## TEXAS NATURAL RESOURCE CONSERVATION COMMISSION

Re: EDWARDS AQUIFER, Comal County  
PROJECT: Mission Ridge Subdivision, Project number 1301.00, Located immediately west of the intersection of Kerlick and Valley View Lane, New Braunfels, Texas  
TYPE: Request for Approval of Water Pollution Abatement Plan (WPAP); 30 Texas Administrative Code (TAC) §213.5(b); Edwards Aquifer Protection Program

## TEXAS COMMISSION ON ENVIRONMENTAL QUALITY

Re: EDWARDS AQUIFER, Bexar County  
PROJECT: Mission Ridge Subdivision, Project number 1301.01;  
Regulated Entity No. RN102749595; Investigation No. 615460  
TYPE: Solution Feature/Sensitive Feature; 30 Texas Administrative Code (TAC)  
§213.5(f) (2); Edwards Aquifer Protection Program

MISSION RIDGE SUBDIVISION UNIT 2  
PROFILE "SOLUTION CAVITY"

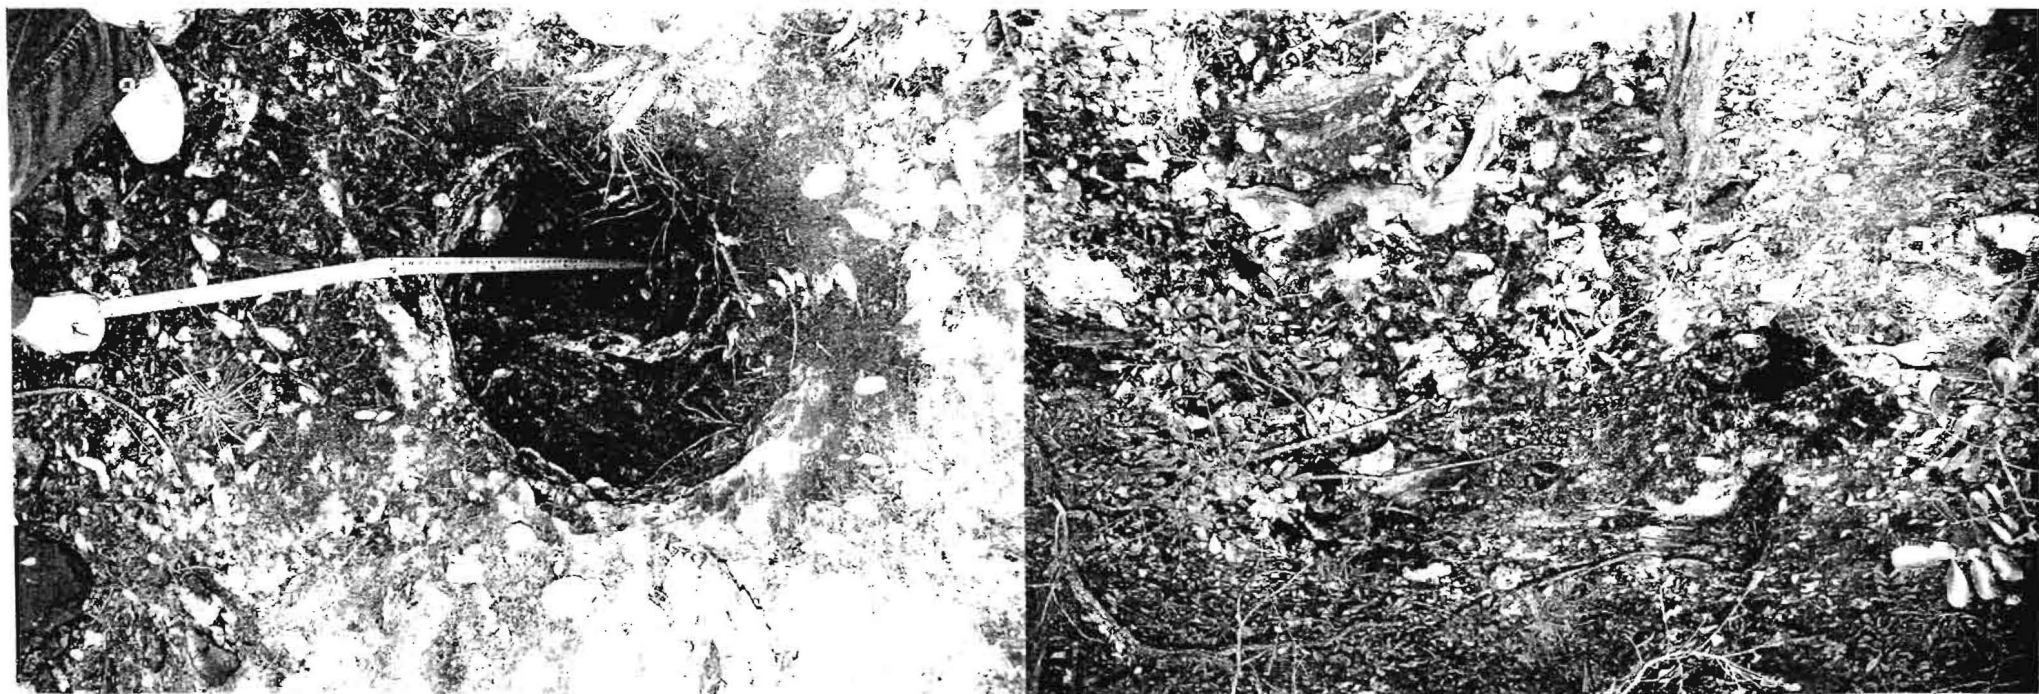
A representative of the San Antonio Region office did not conduct an on site investigation. The engineered resolution submitted for this feature is in the enclosed Solution Feature Discovery Notification Form, attachments and drawings. Based on the information provided, and its certification by Mr. Paul A. Schroeder, P.E., your protection plan is approved with the following conditions:

1. The location of the solution feature shall be shown on the "as-built" plans.

No trenching of any kind is in the vicinity of the solution cavity, therefore it is the recommendation of the engineer that the solution cavity be filled with compacted gravel to provide a solid foundation for a residential structure. The opening will be sealed with a three inch concrete "slab" extending three feet from the edges of the opening in all directions prior to construction of the residential slab (see Profile in Attachment 1).
